NUMBER: 83-13

POWER TRIM PUMP TO POWER TRIM SOLENOID WIRING HARNESS ROUTING 1984 MODELS 75-90-115

Figure 2. New Harness Routing

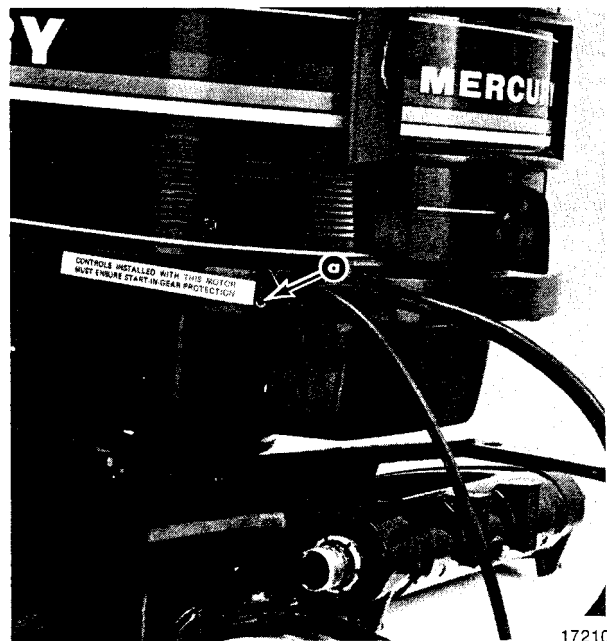
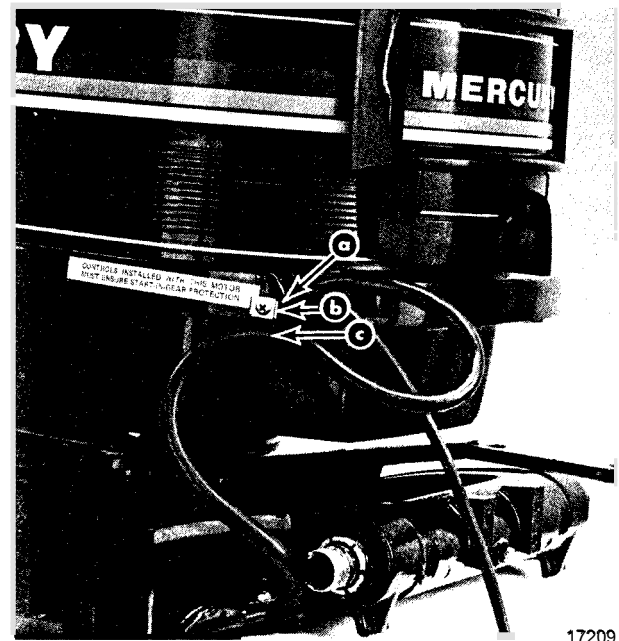
A potential steering interference exists with the routing of the Power Trim pump to Power Trim solenoid on 1984 model 75-90-115 outboards. The problem can occur as the wiring harness makes its way along the right transom bracket. With the generous loop forward, prior to entering the powerhead, the harness can catch under the steering arm when the outboard is tilted full up and then let down again. This would restrict the amount of steering travel.

All 1984 model 75-90-115 outboards that do not have the Power Trim pump to Power Trim solenoid harness routed, as shown in Figure 2, must be reworked as follows:

1. Drill a 5/32" hole approximately 3/4" past the "Start in Gear" blue decal. (Figure 1)
2. Place a harness clip, part number 54-22875, on the harness and route the harness as shown in Figure 2.
3. Secure the harness and clip to the bottom cowl with washer, part number 69205 and self tapping screw, part number 10-69079.

Rework all 1984 model 75-90-115 outboards as shown in Figure 2. .5 hour will be allowed for each rework. Send warranty claims to your Distribution Center.
